SERVICE BULLETIN

Reference number:	SB-09-1218	Issued: 28 January, 2019
Subject:	Loose Exhaust Finishers	
Model(s):	Vantage 19MY	
VIN Range:	All	
Applicable to:	All Dealers	
Distribute to:	After Sales Manager Executive Manager Service Manager Sales Manager	Warranty Staff Technician(s) Parts Staff

Figure 1

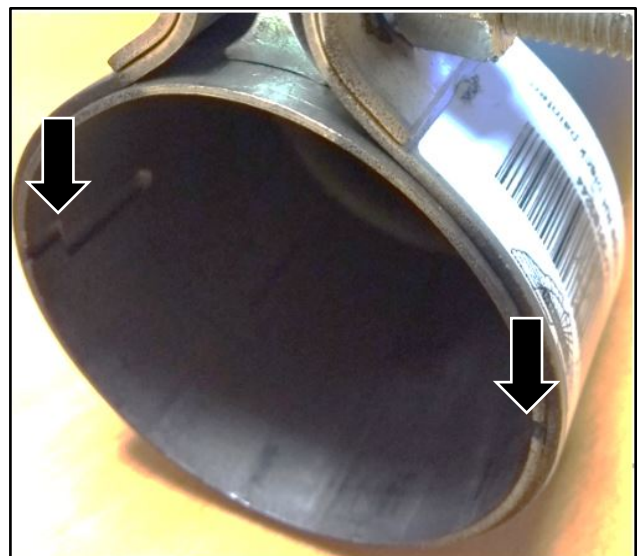
1. Do a push pull test of each exhaust finisher to check if it is loose.
2. If an exhaust finisher is loose, remove the exhaust finisher from the vehicle (refer to Workshop Manual Procedure 01.19.BX).
3. Each exhaust finisher has two slots (refer to Figure 1).

Figure 2

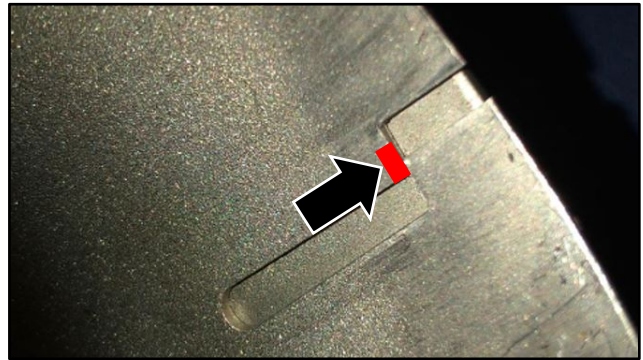
4. Use an applicable tool to cut 1mm of exhaust finisher material from the area shown (refer to Figure 2).
